Affected Publication: API Spec 8C/ISO 13535, *Specification for Drilling and Production Hoisting Equipment (PSL 1 and PSL 2)*, Fourth Edition, February 2003

Addendum 2

ADDENDUM 1

Specification for Drilling and Production Hoisting Equipment (PSL 1 and PSL 2)

Figure 3 — Equivalent-round models — Keel block configuration

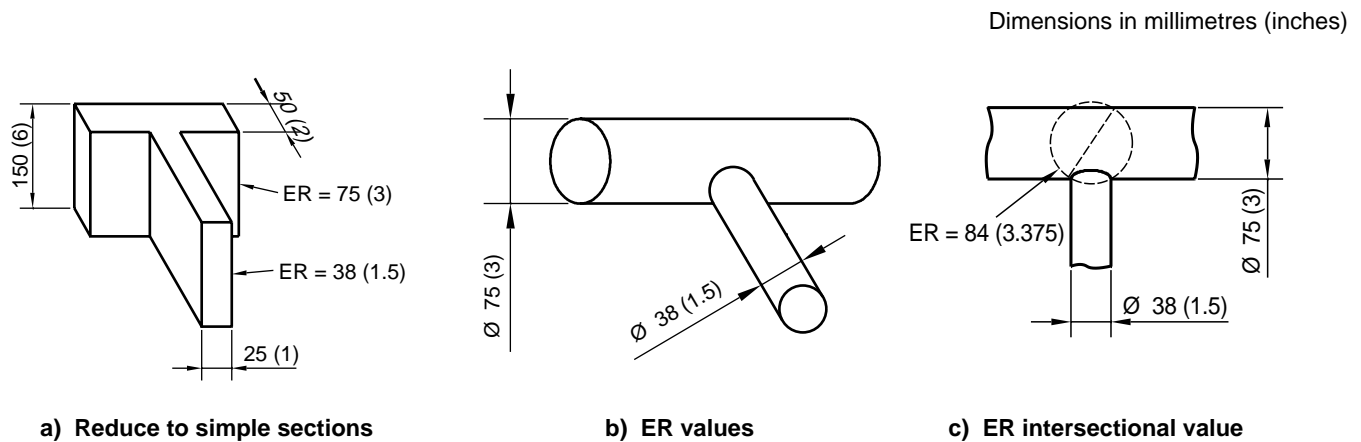
- Table 8 & 9 Note 1: change “Figure 7” to “Figure 10.”
- Table 10: Change short tons to Kips.
- Figure 3: Note change “1/4 -T” to “1/4 T.”
- Figure 6: Change “D” to “D_t.”

Figure 11 — Rotary swivel connections

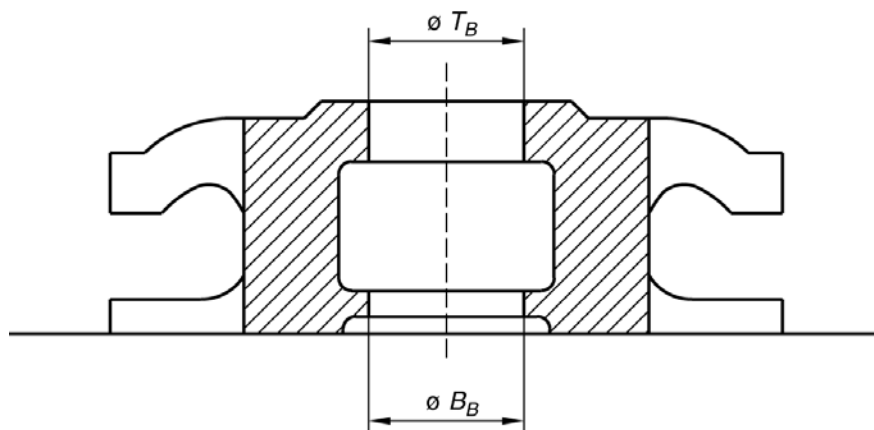
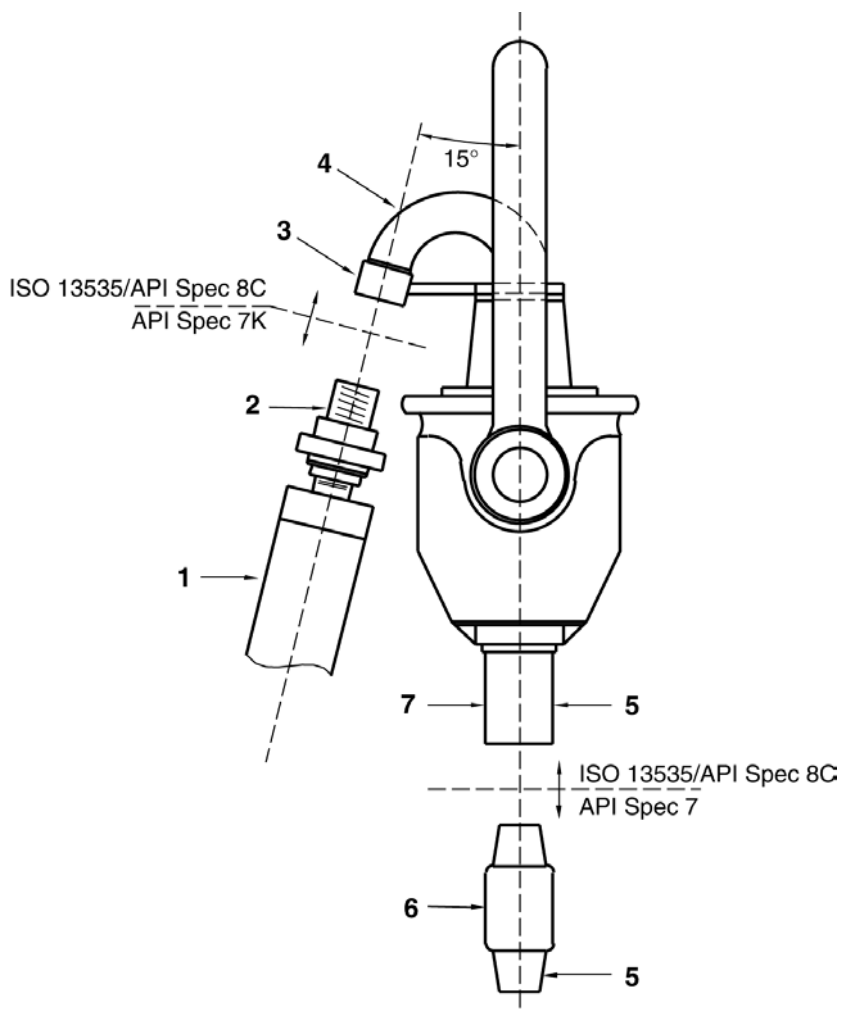
- Figure 11: at the specification split line add “/API Spec 8C” after ISO 13535.
- Figure 11: at the split between key 2 & 3 change API Spec 7 to API Spec 7K.
